SONARtrac® Technical Bulletin

Subject: Installation of Sensor Bands

TB004 | Rev: 02

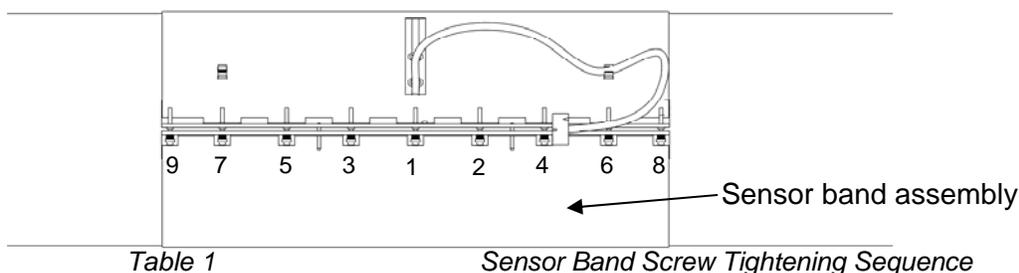
Technical Bulletin 004 was released on November 1, 2004 calling for additional tightening of the sensor screws. Since that time we have learned that we may be over-tightening the small size sensor bands (sizes 2 inch through 6 inch).

2. Starting at screw #1 in Figure 1, tighten screws #1 - #7 an additional one-half turn in the given numbered sequence. Do not tighten screws # 8 and 9.

1. Install and tighten the sensor band screws in accordance with the procedure given in the Installation Manual. That is, tighten the screws a few turns at a time per the tightening sequence shown in Figure 1. Use the sensor band spacer tool to set the compression on the Bellville washers.

1. Install and tighten the sensor band screws in accordance with the procedure given in the Installation Manual. That is, tighten the screws a few turns at a time per the tightening sequence shown in Figure 1. Use the sensor band spacer tool to set the compression on the Bellville washers.
2. Starting at screw #1 in Figure 1, tighten each screw one-half turn in the given numbered sequence.
3. Once all nine screws have been tightened, tighten each screw an additional one-half turn in the given numbered sequence.

4. Once all nine screws have been tightened a second time, tighten screws #1-7 an additional one-half turn in the given numbered sequence.
